SERVICE INFO

Assembly instructions for LuK RepSet® 621 3027 09/33/34, 621 3045 09/33 and 621 3050 09/33

Image 1: OE no. 90536140 / 616169
without indentation around the
circumference, flywheel depth
19 mm

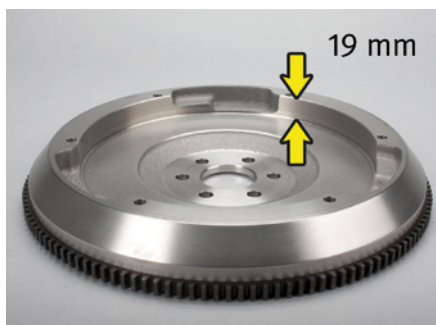
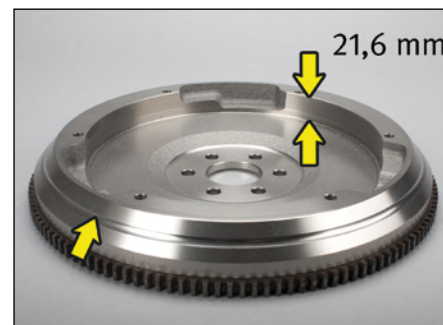
In the models listed, the clutch can sometimes grab. The problem mainly occurs after long standing times and in ambient temperatures below 10°C.

From May 2007, the vehicle manufacturer has therefore installed a modified clutch and flywheel as standard. As a result, the flywheel depth changed from 19 to 21.6 mm.

Image 2: OE no. 93186460 / 5616016
with indentation around the
circumference, flywheel depth
21.6 mm

Flywheel OE no	LuK RepSet®
90536140/616169 gearbox without coloured marking, flywheel depth 19 mm	621 3027 09 621 3027 33 621 3027 34
93186460/5616016 gearbox with coloured marking, flywheel depth 21,6 mm	621 3045 09 621 3045 33 621 3050 09 621 3050 33
